## **AMENDMENTS TO THE DRAWINGS**

## REMARKS

Fig. 3

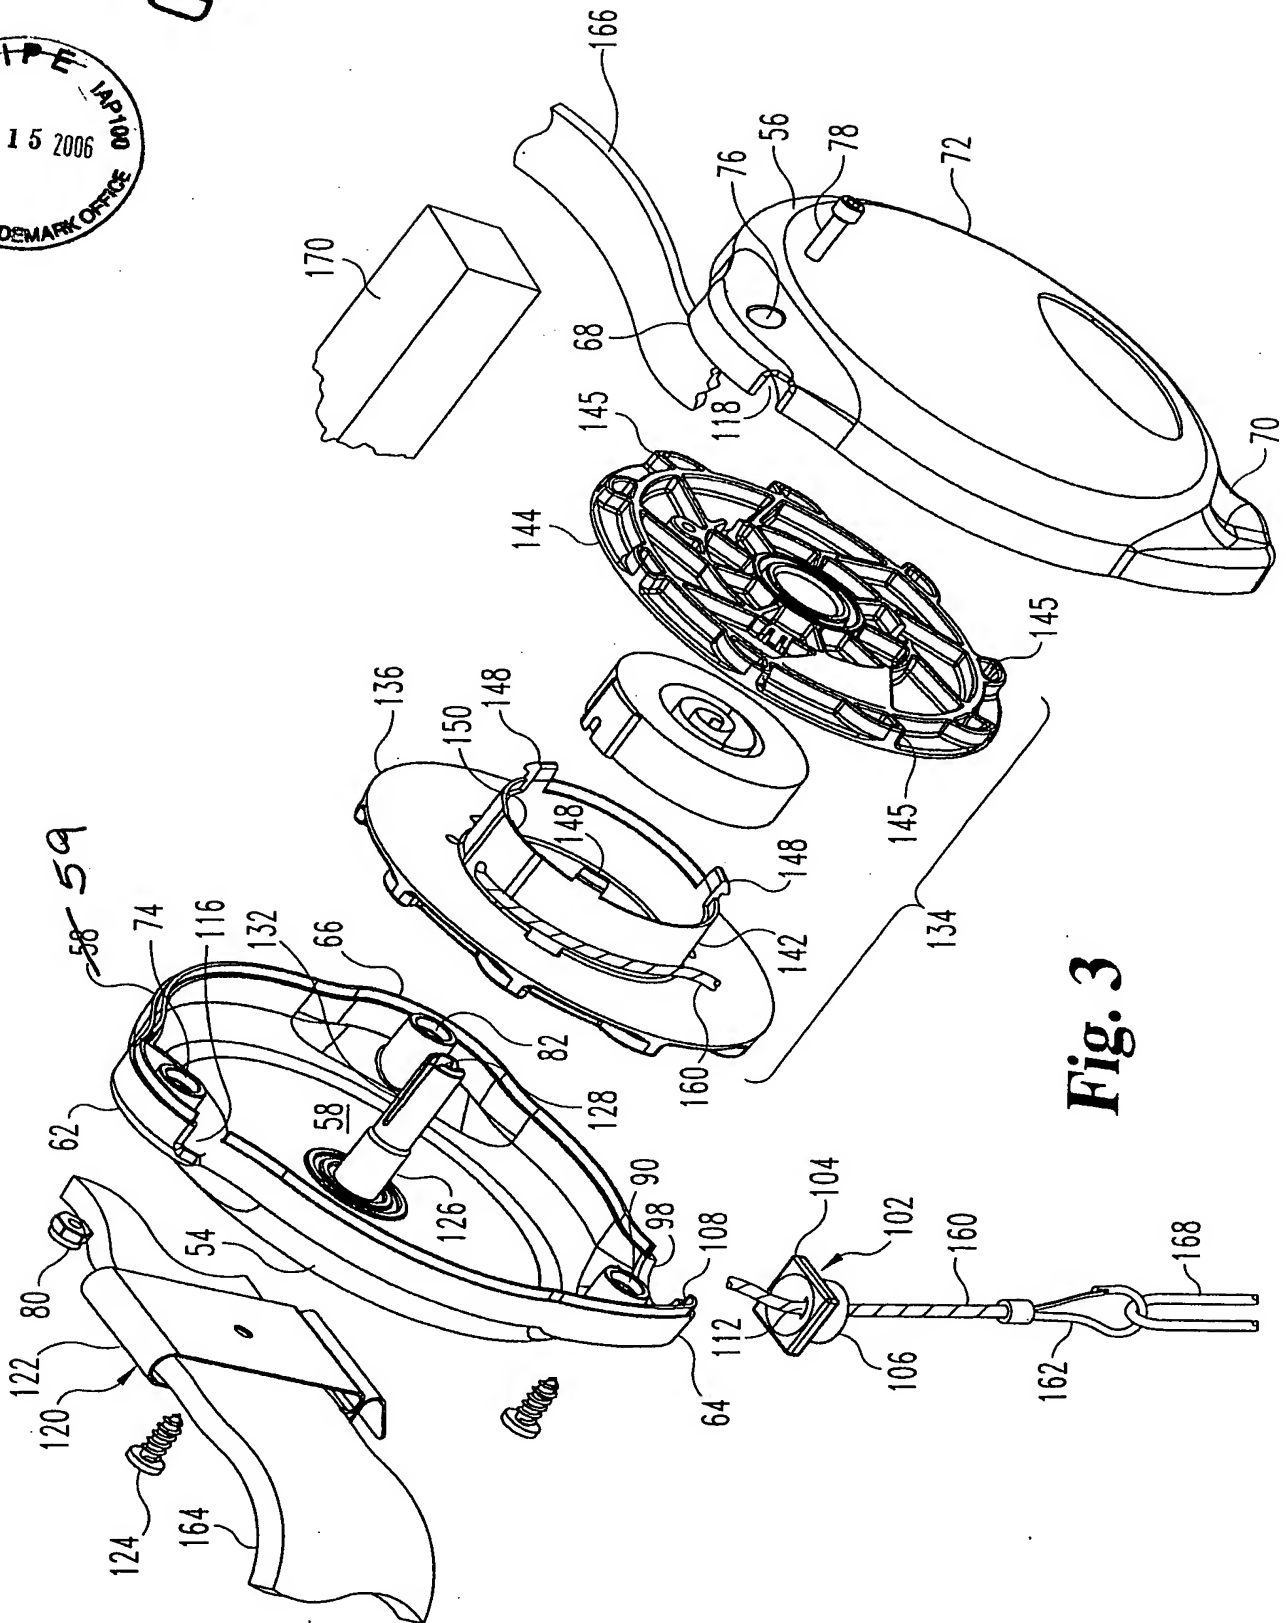
Drawing sheets containing Figures 3 and 4 have been submitted to cure the objections pointed out by the Examiner. For Figure 3, reference character 58 designating the perimeter flange has been changed to 59, thereby avoiding duplication. In Figure 4, the unnamed screw at the upper right corner of the drawing has been designated 78, as well as nut 80 in the lower left hand corner of the drawing to conform with the reference characters of Figure 3. It is believed that these amended drawings comply with the requirements of 37 CFR 1.121(d). Two sheets of red-marked drawings are enclosed. Anticipating approval of the drawing amendments by the Examiner, two replacement sheets are also being forwarded. Accordingly, the objection to the drawings is appropriate to be withdrawn.
